2020 Regional Annual Training

Changes and Clarifications: 2020 Storm Water Low Impact Development Technical Design Manual

By: Flannery Banks, Assistant Engineer – Storm Water and Creeks
City of Santa Rosa – Water Department

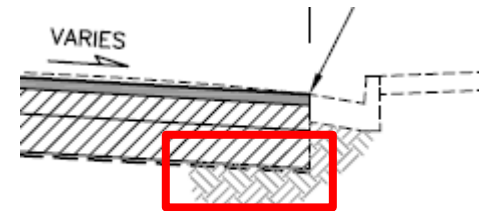
Subgrade: That portion of roadway on which pavement surfacing, aggregate base, subbase or a layer of any other material is placed (also known as the grading plane or the point at which soil would be exposed and/or disturbed).

⁵ Impervious surface replacement, such as the reconstruction of parking lots or excavation to roadway subgrades, is not a routine maintenance activity. Reconstruction is defined as work that replaces surfaces down to the subgrade. Overlays, resurfacing, trenching and patching are defined as maintenance activities. (Permit, p. 26)
